**TOWN OF MOUNTAIN VILLAGE  
DESIGN REVIEW BOARD REGULAR MEETING  
THURSDAY AUGUST 4, 2016 10:00 AM  
2nd FLOOR CONFERENCE ROOM, MOUNTAIN VILLAGE TOWN HALL  
455 MOUNTAIN VILLAGE BLVD, MOUNTAIN VILLAGE, COLORADO  
AGENDA**

**SUMMARY OF MOTIONS  
TOWN OF MOUNTAIN VILLAGE  
DESIGN REVIEW BOARD MEETING  
THURSDAY JULY 7, 2016**

**LOT 181 MOUNTAIN VILLAGE  
DRB FINAL APPROVAL - RESUBMITTAL  
7.20.16**

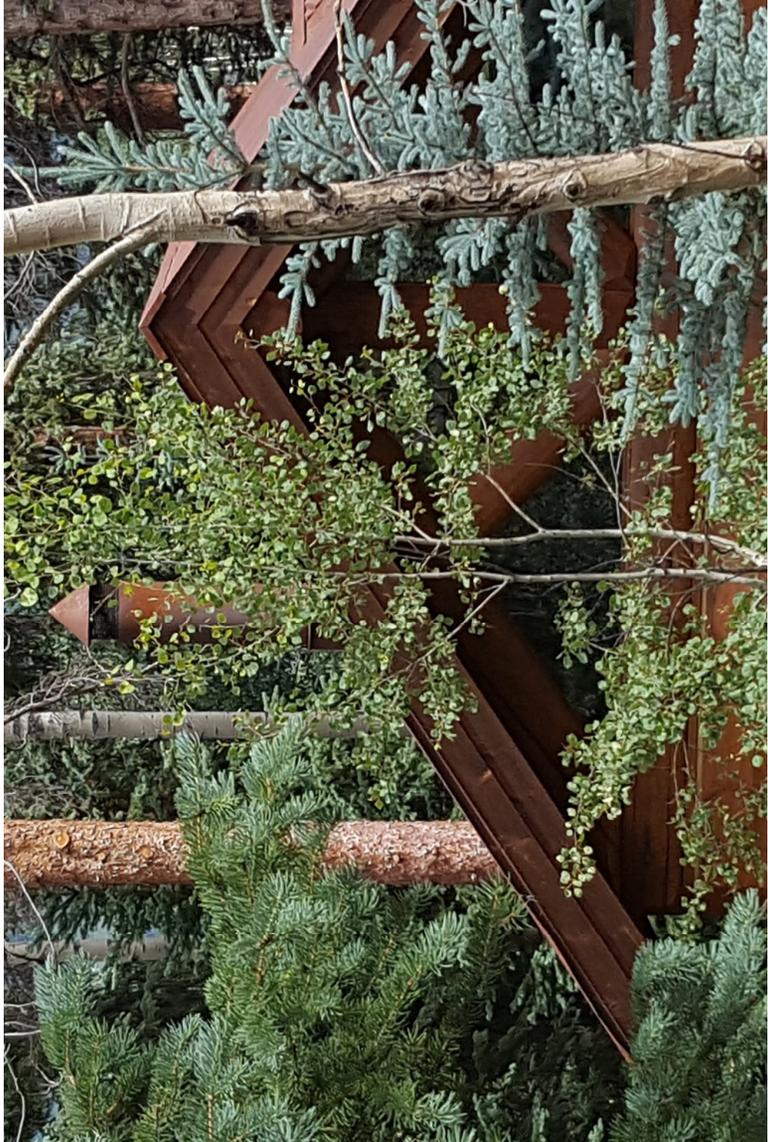
**We received a general list of items of concern from the DRB at the July 7 hearing that we have attempted to address in the resubmittal of our plans. These items include:**

**1 – Carport design – A majority of the DRB members were opposed to the originally submitted full length carport that encompassed 2 protected parking spaces, so we eliminated the carport and provided a 12’ overhang that we indicated on the west side of the home at our previous hearing. We have since further reduced this overhang from 12’ to 8’ and maintained the columns in order to provide some consistency with the overhang on the terrace south of the living room, to provide architectural interest on that end of the home and to provide some protection for the trash storage area and garage entry door below.**

**2 – Outdoor lighting plan – We were asked to study the outdoor lighting plan and reduce the number of fixtures. Upon review we previously submitted a plan with a 48 fixtures that were a combination of recessed steplights, recessed downlights and freestanding landscape post lights. Our revised lighting plan now consists of 22 steplights and downlights resulting in a reduction of over 50%. Additional information on the individual fixtures has been provided including trim, beam spread and wattage. It should also be noted that the project next door on Lot 182 to the south had a combined 43 fixtures approved for their exterior lighting plan, with quite a few of them exposed decorative fixtures.**

**3 – Chimney flue – The board had some hesitation with our chimney design being an exposed metal flue which seemed to contradict the CDC. To clarify, our chimney is a circular steel surround that would hide our actual chimney flue inside of it. Attached are a series of images of metal chimney flue surrounds that were previously approved throughout Mountain Village over the years. We feel that our chimney design is in compliance with the design theme of the community and we hesitate to add a large stone chimney surround by extending the fireplace up through the roof, adding unnecessary mass up high.**

**4 – Window trim – We were asked to study options for window trim although no requirements or conditions were stated. The design aesthetic of our home results in clean lines and very little unnecessary ornamentation on the building. The windows in the living area have no trim since they are a series of units mullied together and any windows in the stone walls are recessed and have stone returns which is quite common throughout Mountain Village. So we focused our design energy on the windows in wood siding, mainly on the south and north elevations. The treatment of our vertical siding and it's varied widths would be interrupted by window trim if we were to apply it on the sides and our barn doors would need to hang out past this trim in order to pass by and cover the glazing. The area below the doors and windows is a trim piece in dark metal that will show from the bottom of the door to the deck, approximately 5". We feel any additional trim added will distract from the design intent.**
